**CITY OF PORTLAND, MAINE  
DEVELOPMENT REVIEW APPLICATION  
PLANNING DEPARTMENT PROCESSING FORM  
DRC Copy**

Hanover Street Parking Lot  
Project Name/Description

**Subject: Hanover Street Parking Lot  
Response to Comments in April 4, 2002 E-Mail**

**Subject: Hanover Street Parking Lot  
Response to City Review Comments**

**SITE LAYOUT, STRIPING AND LANDSCAPING PLAN**

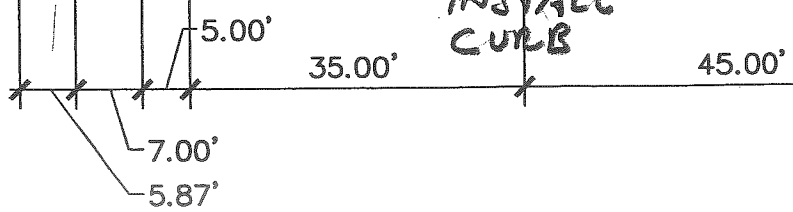
1. WE WILL NEED A COPY OF A FINAL AGREEMENT BETWEEN THE APPLICANT AND CENTURY TIRE REGARDING THE DRAINAGE EASEMENT AND CONNECTING INTO THE CATCH BASIN
2. CENTURY TIRE DUMPSTER WILL NEED TO BE SCREENED ON ALL 4 SIDES PRESUMABLY BY A SOLID WOOD FENCE.
3. ADD A THIRD STREET TREE ALONG HANOVER STREET.
4. SIDEWALK ALONG HANOVER STREET SHOULD BE CONCRETE
5. SEE ATTACHED SKETCH ON CURB AND LANDSCAPING NEAR CENTURY TIRE
6. I ASSUME THERE ARE BREAKS BETWEEN THE TIMBERS SO THAT WATER IS NOT DAMMED UP. NOT TOTALLY SOLD ON THE TIMBER CONCEPT, HOW ARE THEY GOING TO BE SECURED IN THE GROUND? IN THE LONG RUN, I THINK WE ALL WOULD BE BETTER SERVED BY CONCRETE CURB STOPS. THEY ARE MORE DURABLE THAN WOOD AND CAN BE USED LATER.
7. LIGHTING DISCUSSED PREVIOUSLY.

**INSTALL CURB**  
**PLANT AUSTRIAN PING 6 TO 8 FEET HIGH**

**INSTALL CURB**

5. Response: Concrete curb stops have been shown around the landscaped island and the dumpster. An Austrian Pine has been shown in the landscape island.

| Drawing No. SDFIT |

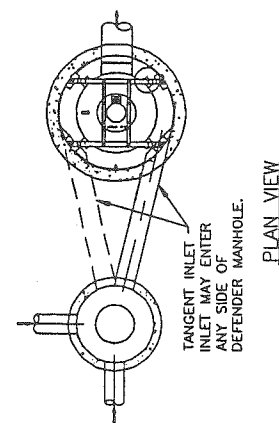
The stormwater is proposed as being treated by a Downstream Defender for water quality purposes. No calculations describing flow rate generation, sliding scale TSS removal treatment efficiency levels, or tank sizing (storm event capabilities) were included. Also, a detail with the design parameters should be included on the detail sheet.

1. Response: Sizing calculations for the Downstream Defender are enclosed. A catalog cut for the Downstream Defender was enclosed for the last submission. It's design parameters are shown on the attached Hydro International details.

# SITE LAYOUT, STRIPING AND LANDSCAPING PLAN

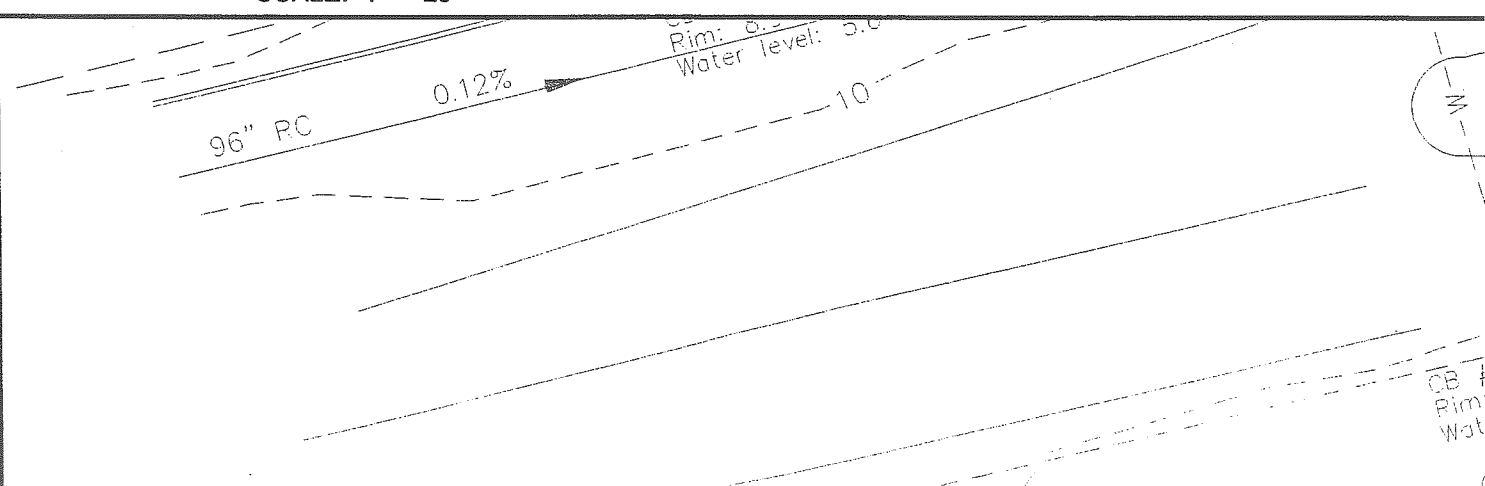
1. Submit copy of the property deed including right, title and interest to the property.
2. Provide documentation on the sizing calculations of the Downstream Defender.

3. It appears that the 8 inch ADS line is connected into a catch basin on the Century Tire property. If this line doesn't already exist, do you have permission to construct and connect this line into their catch basin? Please clarify. If this is a new line into that catch basin, we will need documentation on an agreement from that property owner. Also a 10 inch line rather than an 8 inch line should be used.

4. Rather than installing a bituminous sidewalk, install a concrete sidewalk.
5. Remove the following note on the plan: "THE CITY'S BLOCK RETAINING WALL ENCROACHES ON THE ABUTTING PROPERTY AND SHALL BE RELOCATED BY THE CITY PRIOR TO PARKING LOT CONSTRUCTION". This concern needs to be addressed in another forum.

10. Initial comment on landscaping is that another tree should be added along the Hanover Street frontage. More landscaping will likely be needed. We will get specific comments from the City Arborist regarding landscaping.

1. A copy of the deed is attached.
2. Sizing of the Downstream Defender is attached. The Downstream Defender has been shifted outside of the pavement and a catch basin added per recommendations of the manufacturer.

9. The curb was intentionally left off that end of the parking lot to enable sheet flowing of the stormwater runoff and to be consistent with the attached agreement with Century Tire.
10. We await the City arborist's comments.
11. It was intended that the lighting for this site match the lighting proposed for the Bayside Square project. If the proposed revisions to the Bayside Square lighting is approved, the lighting catalog cuts will be provided at that time.
